SYDNEY CENTRAL CITY PLANNING PANEL

COUNCIL ASSESSMENT REPORT

Panel Reference	PPSSCC-427
DA Number	DA/93/2023
LGA	City of Parramatta Council
Proposed Development	A 42 and 43-storey mixed-use development comprising a 3-storey retail and commercial podium (5,804sqm of floorspace), two residential towers of 604 residential apartments and 6 basement levels for 432 car parking spaces. Stratum subdivision of 4 lots for retail and office and residential lots and 604 Strata Subdivision of the 2 residential stratum lots. Demolition of existing structures and removal of trees. The application is nominated integrated development under section 90 of the Water Management Act
Street Address	34 Hassall Street, Parramatta NSW 2150
Property Description	Lot 1 Sec 88 DP758829, Lot 2 Sec 88 DP758829; and Lot 3 Sec 88 DP758829
Applicant	Deicorp Projects (Hassall Street) Pty Ltd
Owner	Minister for Education and Early Childhood
Date of DA lodgement	15 February 2023
Recommendation	Approval subject to conditions

Figure 17: Source Council's GIS and Parramatta Cultural Heritage Study Review, MDCA, August 2014). Hatched red denotes High Sensitivity (Pleistocene Sands) and green denotes low sensitivity.

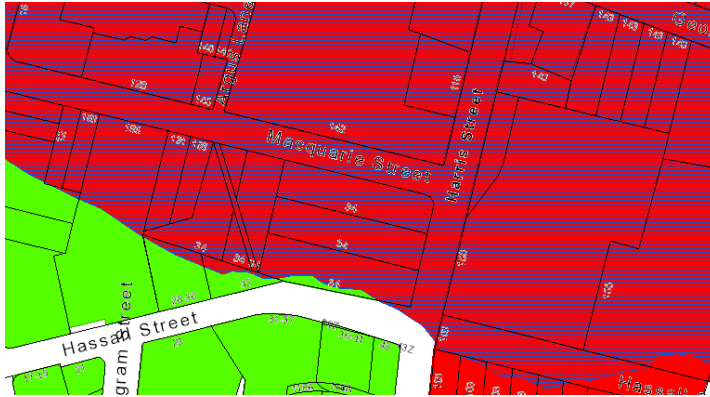
The majority of the site is identified as having 'High Sensitivity' (refer **Figure 17**) and is identified to be located on the Parramatta Sand Body. It is noted that the site however, has no known 'Aboriginal place of heritage significance' (as defined by the PLEP 2011) or found archaeological deposits on the State Heritage Register. Due to its location on the Parramatta Sand Body, Council made a non-statutory referral was made to Heritage NSW.

- The application should not be determined until the testing program verify the presence, nature, extent and significance of cultural heritage on the subject site. An AHIP application for test excavation will be required to be lodged.

Figure 18: Ground floor plan showing Driveway to adjoining Site (marked in dashed blue line)

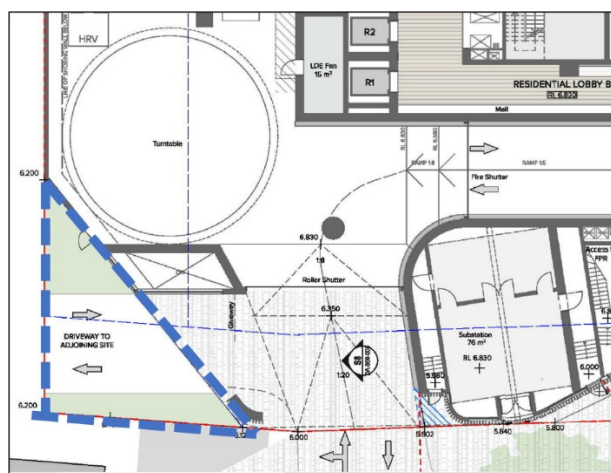
However, TfNSW are also requesting that access be facilitated to 191 – 193 Macquarie Street in order to restrict access along Macquarie Street to protect the Parramatta Light Rail (PLR) corridor. Council does not consider that it can reasonably request access to be facilitated to 191-193 Macquarie Street via the subject site along Hassall Street for a number of reasons:

- The proposed driveway would be required to be redesigned to accommodate many more (unknown number of) residential and / or commercial premises, of which we anticipate require further modelling and widening of the driveway.
- The site is not directly adjacent and ownership is different.
- There is no relevant environmental planning instrument which requires this.

To address this the proposal has been designed so that future access to the remainder of the broader site will be granted via ground level basement access to the remainder of Hassall Street (refer **Figure 18**). As such, access is secured to 193A Macquarie Street.

Figure 19: Option 1 Glass Screen (Source: applicant submission)

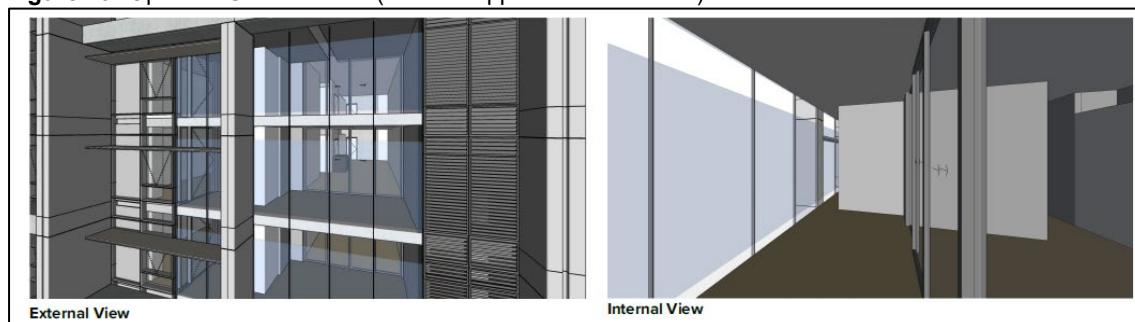
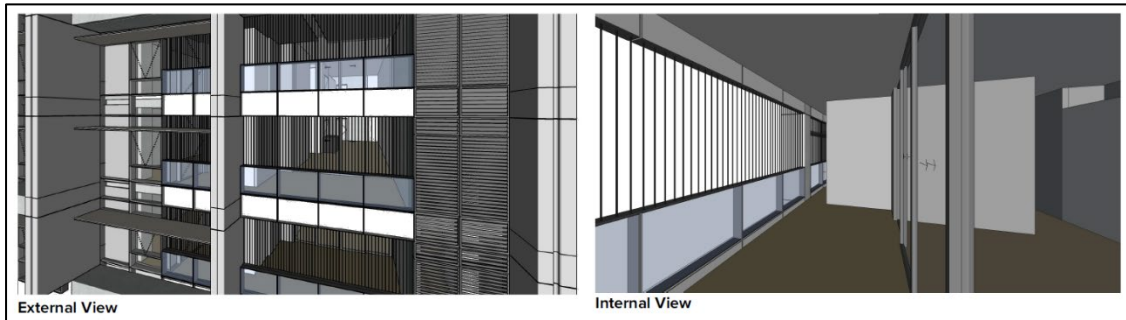
Council is concerned that the redesign of balconies along Macquarie Street with awning, louvres and enclosures etc may result in poor amenity outcomes for residents in terms of reduced natural ventilation and solar access, as well as impacting on the design excellence standards of the design. Therefore, Council asked the applicant to submit some options of how they may design the balconies as a result of TfNSW requirement. The applicant submitted the following two options (refer **Figures 19 and 20**). It is noted that approximately 84 northern balconies are impacted (4 in Tower B, and 80 in Tower A).

An initial assessment, Council prefers the design of the cable screen (Option 2) as it does not impact significantly on natural ventilation and solar access (as opposed to glass which would impact on ventilation), however requires further analysis (e.g. elevations) to come to a conclusion. Due to the concerns Council has raised, and notwithstanding TfNSW condition, Council recommends an additional condition that requires Council's consultation and confirmation on the proposed treatment of the subject balconies.

Figure 21: Flood Enquiry Extract – the subject site in red outline (Source: City of Parramatta, April 2022)

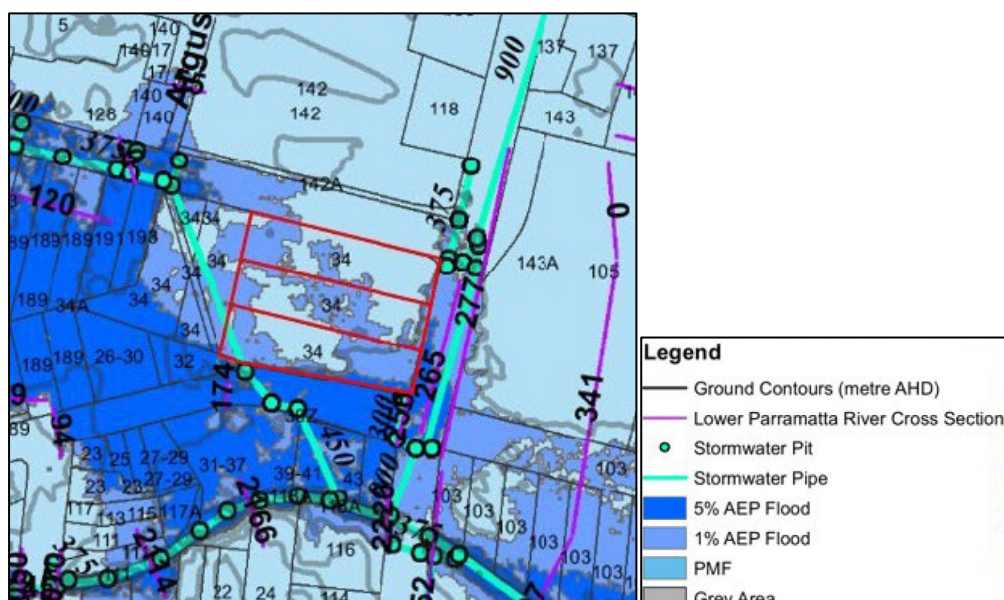
As shown in **Figure 21** below, the site is located within the PMF and is affected by the 1% annual exceedance probability (AEP) Flood in parts and the 5% AEP Flood on the Hassall Street frontage and a portion of the Harris Street Frontage. A Flood Report was prepared by Mott MacDonald and submitted with the application.

Figure 22: Tree Plan showing Jacaranda Trees Numbered 20, 24, 25, 26, 27, 30, 31 and 32 (Extract from Arboricultural Assessment)

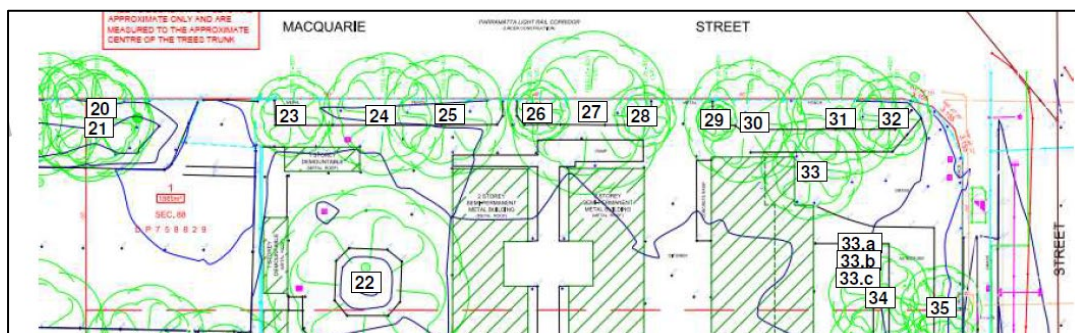
The row of eight significant Jacaranda trees located along Macquarie Street (refer **Figures 22, 23 and 24**) are proposed to be removed. The applicant has provided a supporting Jacaranda Tree Review Memorandum (dated 26 April 2023). Council considers these Jacaranda trees significant in their landscape due to their size, location and longevity in the streetscape, however they are not specifically nominated on the Tree Register or heritage listed.

Although it is not an ideal outcome to remove these trees, on balance, it is concluded that the trees would be heavily compromised from both the proposed development and the operational needs of the PLR. If the trees were to remain, it is likely they would not survive within a 6 metre setback. It is preferable to ensure that any replacement tree planting on this

- An increase the extent of the tree pits at ground level are required to accommodate additional soil volume.
- The planters and soil volumes are to be contiguous and connected using modular cells under the paving and ramps.
- Trees within the planters to be *Fraxinus pennsylvanica* 'Urbanite', or Ash tree. These trees have symmetrical round luscious foliage (i.e., good canopy growth) and a very tough tree good for a street environment. These can grow up to 10-15m metres high. These trees do not have flowers and are deciduous.
